## **AMENDMENTS TO THE DRAWINGS**

## REMARKS

Application No. 10/750,198  
Amendment Dated December 17, 2004  
Reply to Office Action of October 4, 2004  
Annotated Sheet Showing Changes

FIG. 1

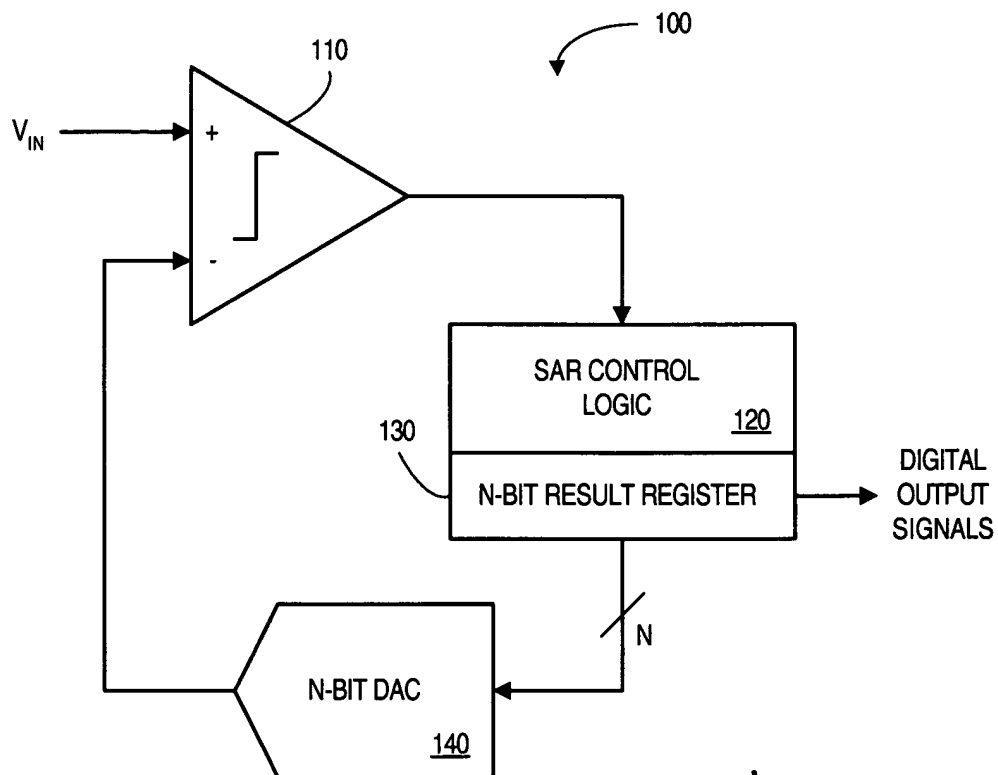
FIGS. 1 and 2 are objected to for lacking a "Prior Art" legend. The FIGS. have been amended as suggested by the Examiner.

add  
"PRIOR  
ART"

The attached replacement sheets of drawings includes changes to FIGS. 1 and 2. The replacement sheets replace the original sheets that included FIGS. 1 and 2. The replacement sheets add the words "PRIOR ART" to each FIG.
